APPLICATION NO.	FILING DATE	FIRST NAMED INVENTOR	ATTORNEY DOCKET NO.	CONFIRMATION NO.
10/815,920	04/01/2004	James Albert Davis	038190/251160	9434

Office Action Summary	Application No.		Applicant(s)	
	10/815,920		DAVIS, JAMES ALBERT	
	Examiner		Art Unit	
	Timothy L. Rude		2871

DETAILED ACTION

Fig. 6

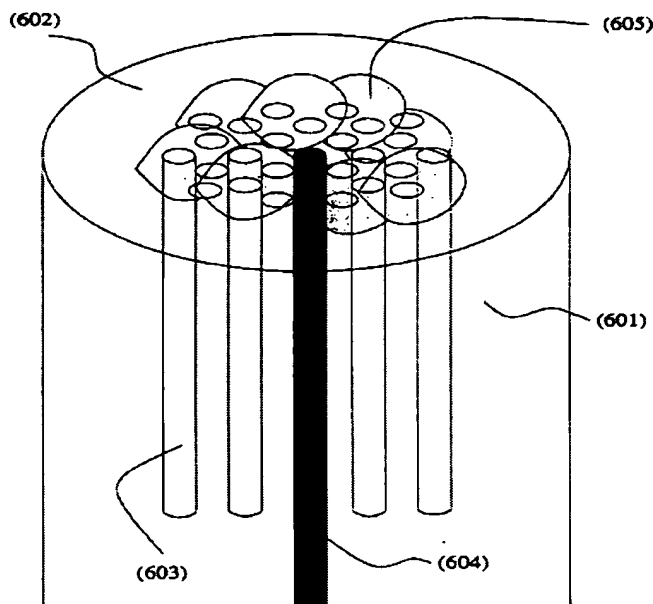
As to claim 1, Bjarklev discloses a system (device) for cooling a fiber amplifier, the system comprising: a fiber amplifier assembly [0016] comprising: a longitudinally-extending fiber amplifier; a jacket surrounding the fiber amplifier and extending at least partially longitudinally therealong, wherein the jacket surrounds the fiber amplifier such that the fiber amplifier assembly defines a passage between the jacket and the fiber amplifier for the circulation of coolant therethrough; and a retaining structure disposed within the passage defined by the fiber amplifier assembly for at least partially maintaining a spacing between the fiber amplifier and jacket, e.g., [0148] and [0183].

Bjarklev does not explicitly disclose a system wherein the retaining structure and coolant comprise an emulsion of phase change material.

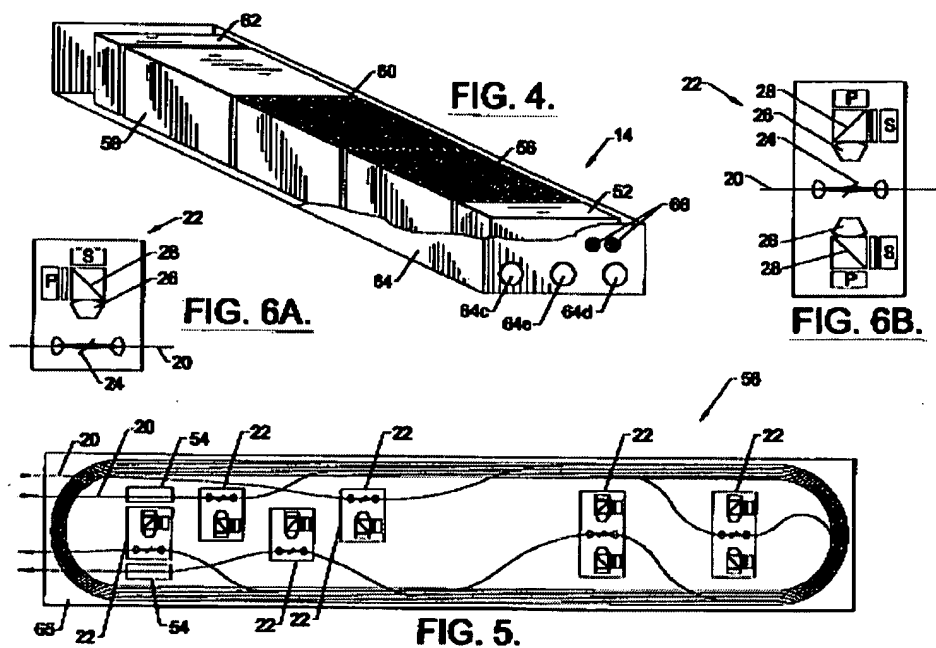
Hollister teaches the use of a micro-encapsulated phase change material [col. 2, line 59 through col. 3, line 4] to improve cooling system performance (better temperature control).

Hollister is evidence that workers of ordinary skill in the art would find the reason, suggestion, or motivation to add a phase change material to the retaining structure and the coolant to improve cooling system performance.

Therefore, it would have been obvious to one having ordinary skill in the art at the time the invention was made to modify the invention of Bjarklev with the phase change material of Hollister added to the retaining structure and the coolant to improve cooling system performance.
